MONTGOMERY COUNTY HISTORIC PRESERVATION COMMISSION
STAFF REPORT

Address:	5816 Surrey St., Chevy Chase	Meeting Date:	4/10/2018
Resource:	Secondary (Post-1915) Resource (Somerset Historic District)	Report Date:	4/3/2018
		Public Notice:	3/28/2018
Applicant:	Neal Thompson	Tax Credit:	Yes
Review:	HAWP	Staff:	Michael Kyne
Case Number:	35/36-18B		
PROPOSAL:	Roof replacement, siding replacement, and patio alterations

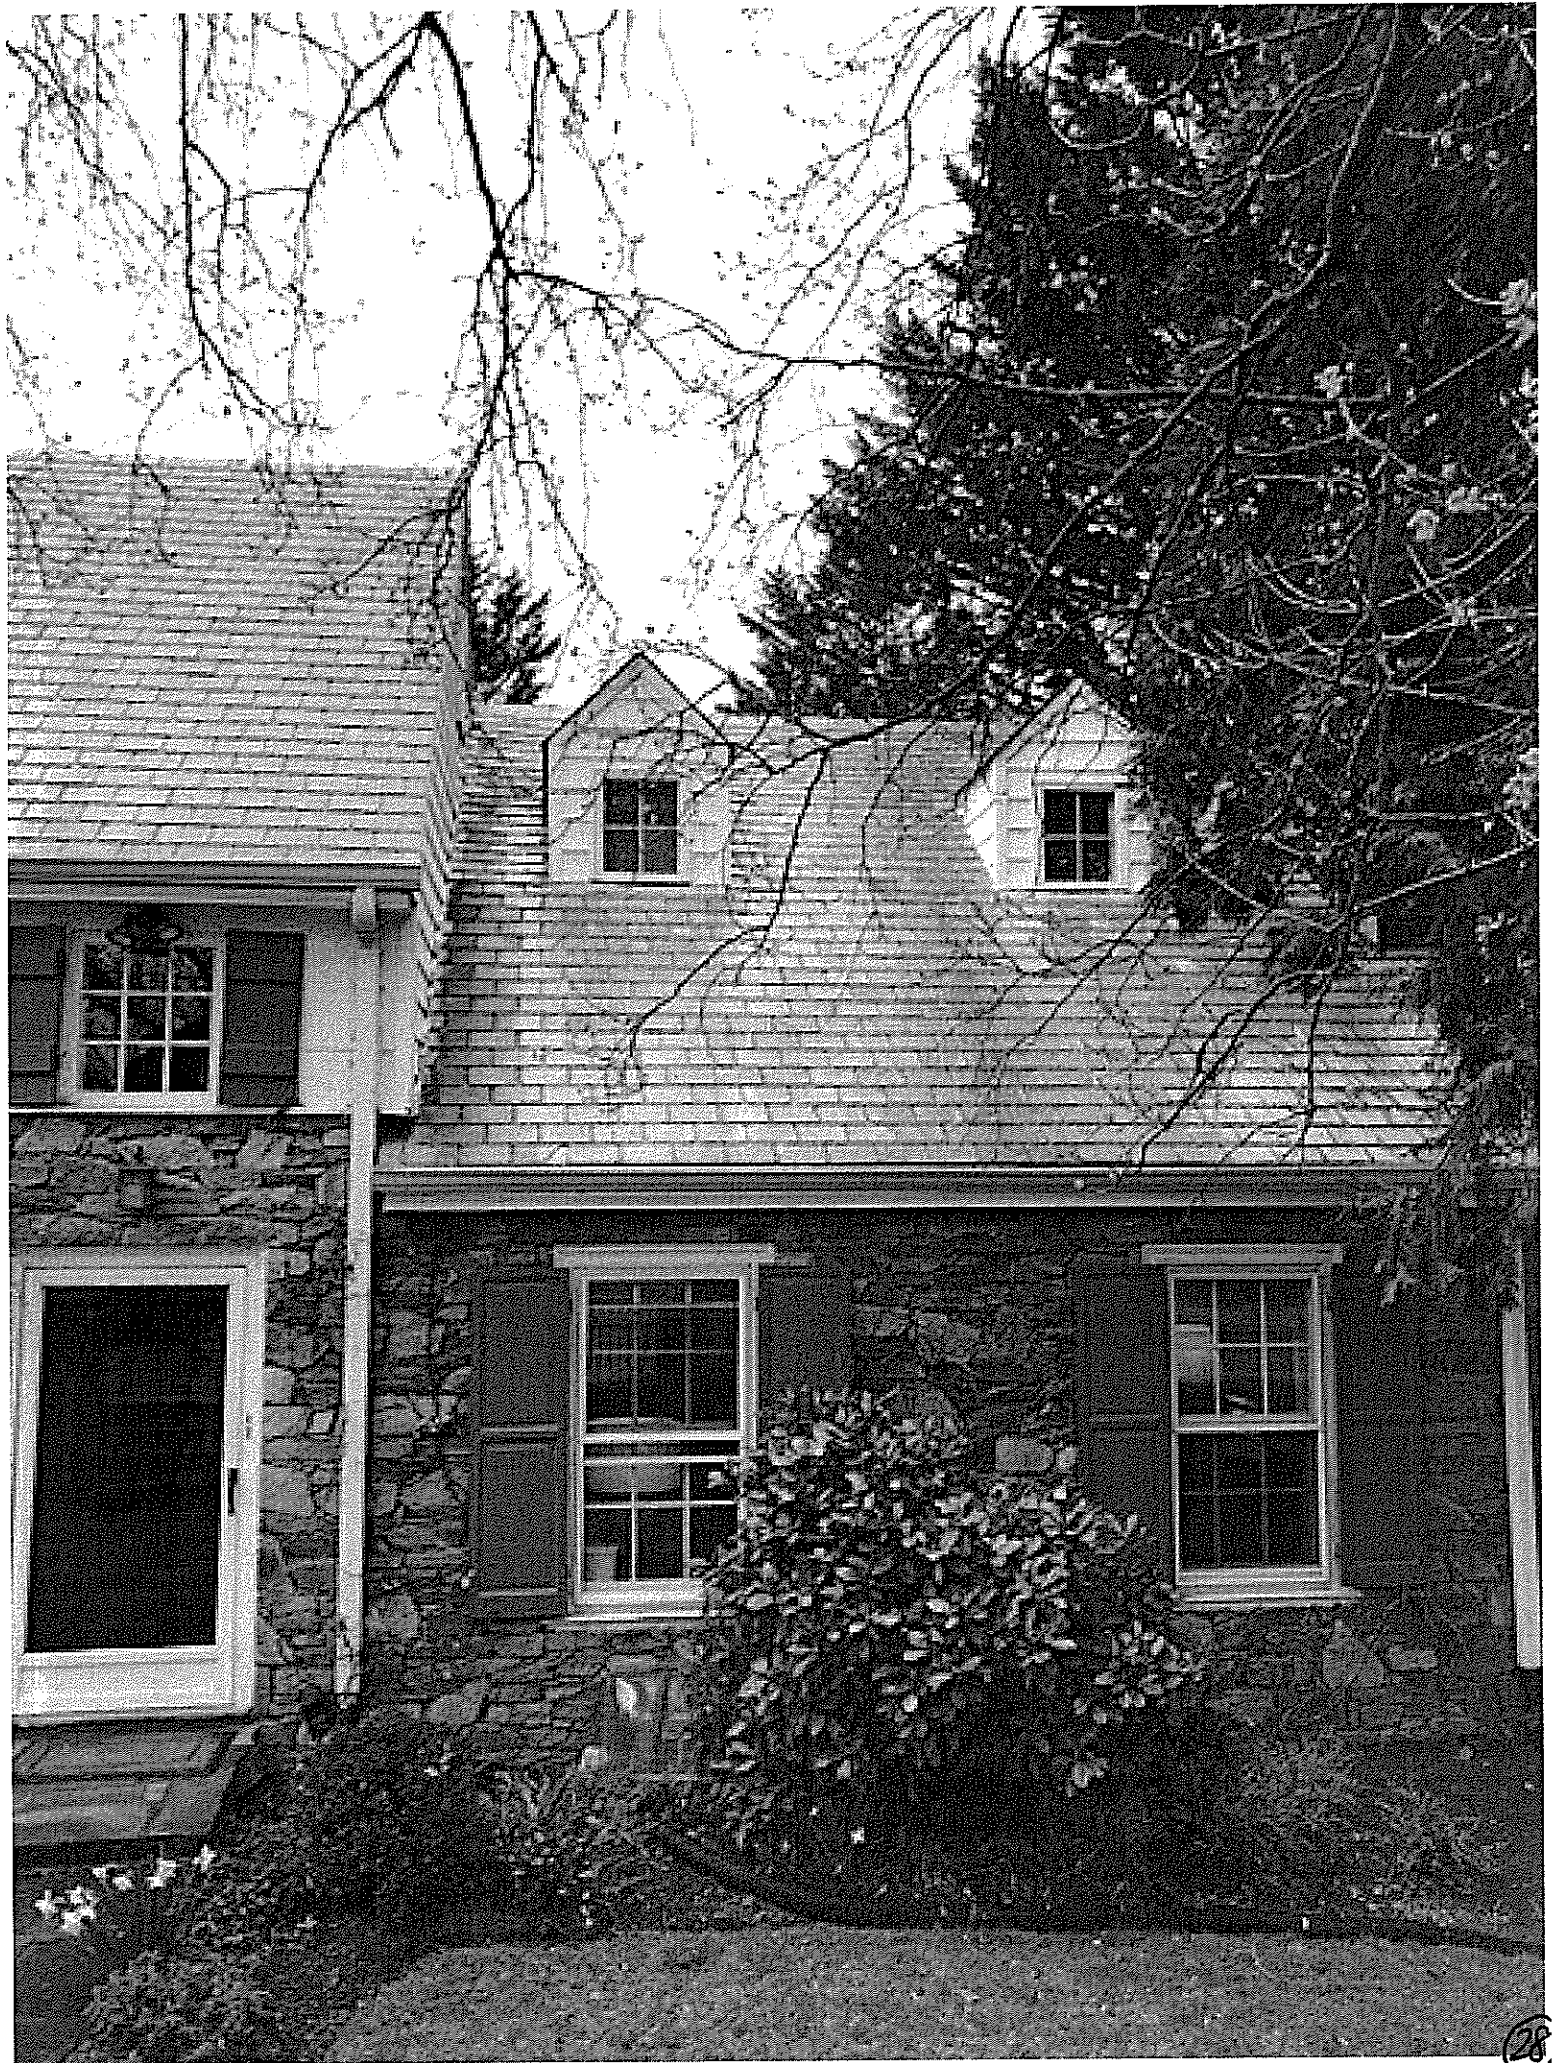
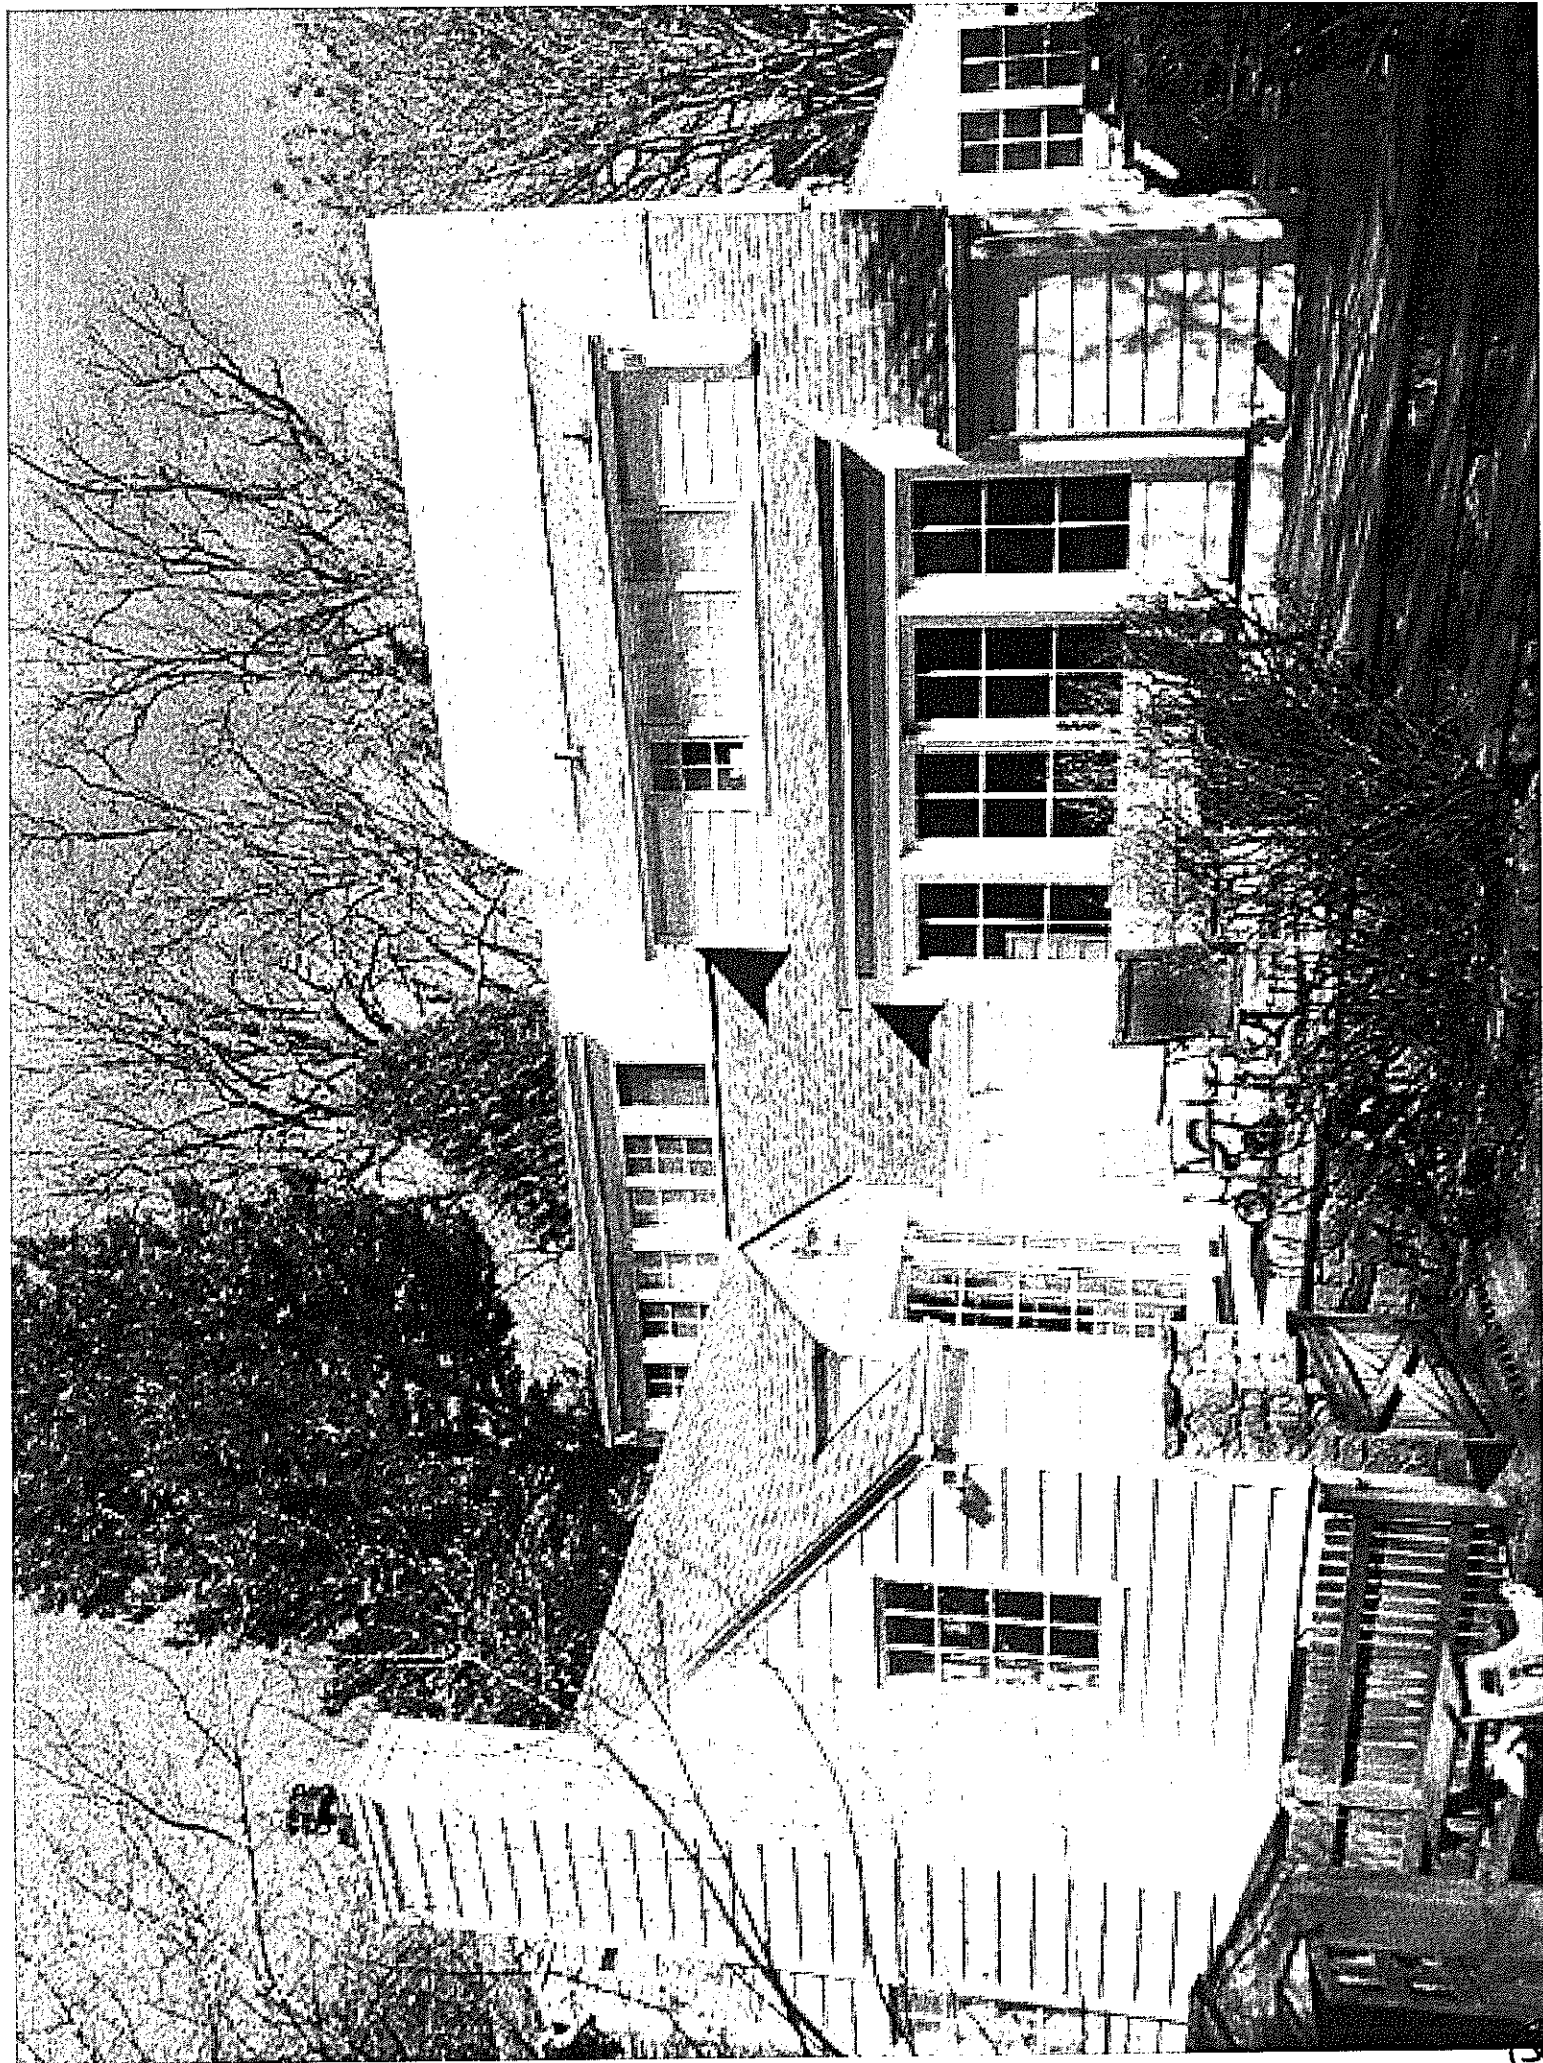
I would propose to replace all the existing slate with new slate to match in exposure and size where it currently exists on the house (Front elevation + portion of rear at the existing roofline). At the newer rooflines (periodic additions added over time) I would like to replace them with an asphalt roofing shingle as that is what exists currently. This will help to offset the additional cost of the slate, and there are clear transitions between the real slate and the asphalt that would make this possible. You can see on the picture of the rear elevation where these existing roofing transitions between slate and asphalt occur.

So in summery, this is a true replacement of roofing material in kind as exists today - original roof slate and addition elements not seen from the front of the property in a new asphalt to match existing.
